PREPARED FOR THE PLAN COMMISSION

**Project Address:** 223 South Pinckney Street (District 4- Ald. Verveer)  
**Application Type:** Planned Development Alteration and Certified Survey Map  
Conditional Use and Demolition Permit  
**Legistar File ID #** [55916](#), [55921](#), [56121](#), & [56288](#)  
**Prepared By:** Kevin Firchow, AICP, Planning Division  
Report includes comments from other City agencies, as noted  
**Reviewed By:** Nan Fey, Interim Director, DPCED

**Proposal Summary:** This request includes modifications to an approved 253-unit hotel and mixed use building to remove one underground level and associated onsite parking, with corresponding façade alterations. A two-lot Certified Survey Map is also proposed to divide the subject property into two lots.

Above: West Wilson Street - Lower Levels of Hotel  
March 22, 2017 Plans

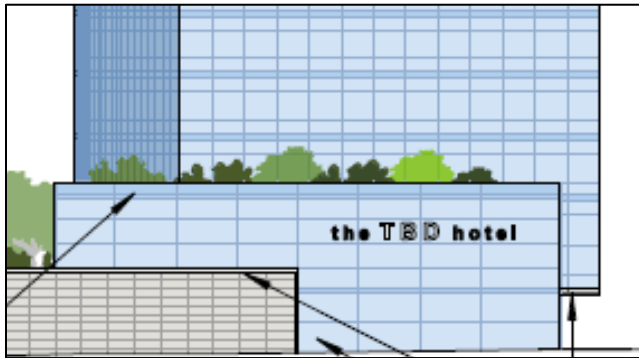
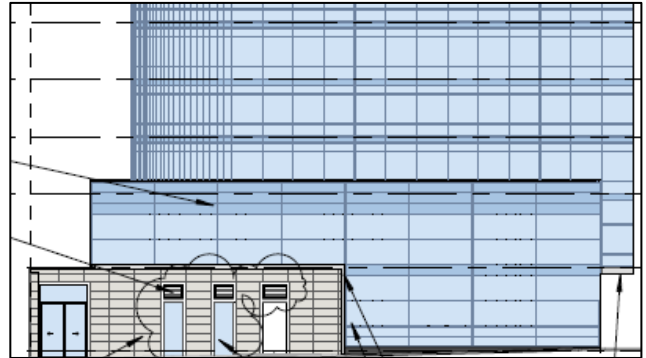
Corresponding façade changes are proposed to the East Wilson and Doty Street façades. Along Wilson Street, the previously approved underground parking entrance is now comprised of a door and spandrel-clad panels. Along Doty Street, additional windows and doors to an enclosed bike parking area are now proposed. No changes are proposed along South Pinckney Street.

Alterations to approved Planned Developments require review by either the Urban Design Commission (UDC) or the UDC Secretary. Considering the limited scope of changes above grade, the UDC Secretary has reviewed this request on behalf of the Commission. The Secretary believes that the removal of the parking ramp access and the corresponding East Wilson Street façade modifications improve the pedestrian character of this block face.
